Technical Service Bulletin

**INTERFERENCE BETWEEN FRONT AND REAR DOOR WINDOW
GLASS MOLDING WHEN OPENING/CLOSING FRONT DOOR**

Bulletin No.: 09-012/26

Detail of A

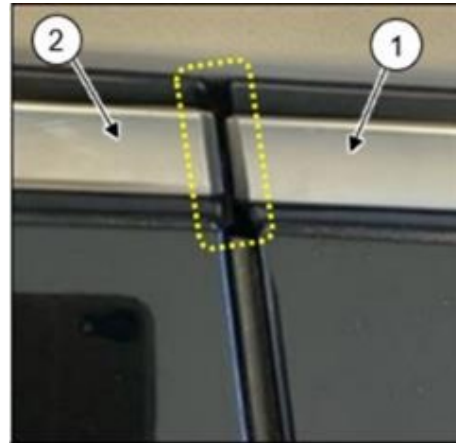
Some vehicles may exhibit an interference between the front (1) and the rear door bright window glass molding (2) due to the bright window glass molding shifting backward when opening/closing the front door.

This is caused by an inappropriate position of the positioning tab on the front door glass run-channel. To eliminate this concern, double-sided tape has been added to the front door glass run-channel, and the shape of the rear end of the front door glass run-channel has been modified to prevent the bright window glass molding from shifting. Customers having this concern should have their vehicle repaired using the following repair procedure.

1. Verify the customer concern.
2. Replace the front glass run-channel(s) with a modified one(s) according to the instructions in MGSS (FRONT DOOR GLASS RUN-CHANNEL REMOVAL/INSTALLATION).
